MIL-C-23269/6C
AMENDMENT 2
20 July 1983
SUPERSEDING
AMENDMENT 1
6 March 1979

MILITARY SPECIFICATION SHEET

CAPACITORS, FIXED, GLASS DIELECTRIC,
(AXIAL-RADIAL WIRE-LEAD TERMINALS), ESTABLISHED RELIABILITY,
STYLE CYR17

This amendment forms a part of Military Specification Sheet MIL-C-23269/6C, dated 30 September 1970, and is approved for use by all Departments and Agencies of the Department of Defense.

FIGURE 1. Dimensions and configurations. "

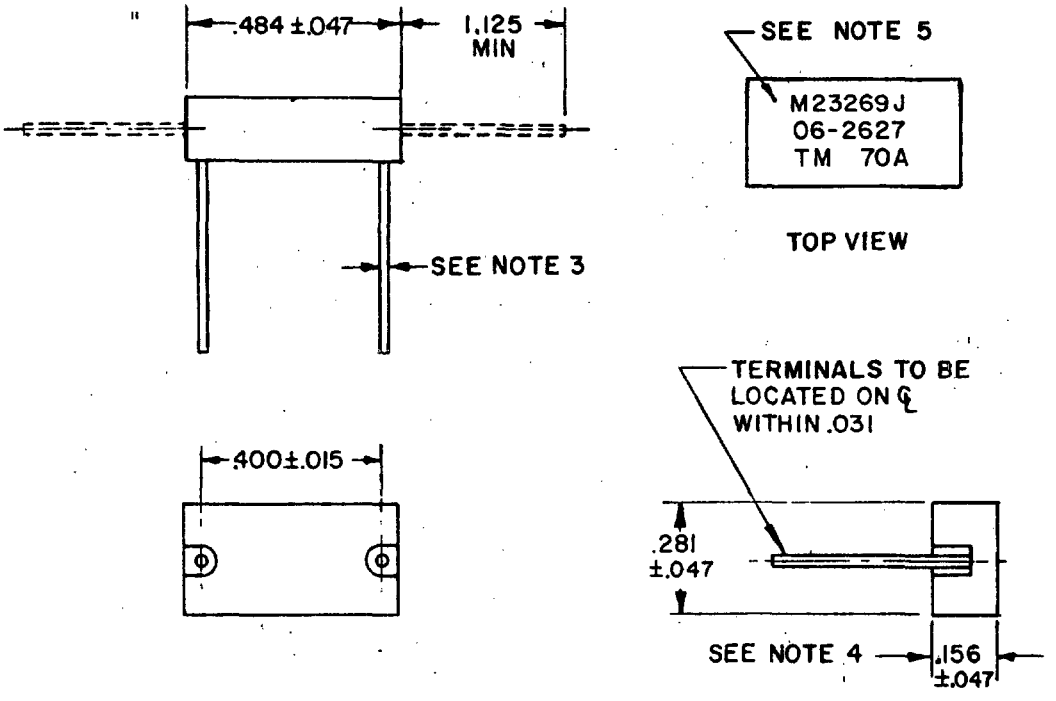
FIGURE 1: Delete and substitute:

NOTES:
1. Dimensions are in inches.
2. Metric equivalents are given for general information only and are based upon 1 inch = 25.4 mm.
3. The lead diameter shall be .025 +.004 ,-.001 for capacitance values less than 330 pF and .032 +.004,-.001 for capacitance values above 300 pF.
4. For any value above 300 pF, this dimension shall be .219 +.062,-.031.
5. See marking requirement.
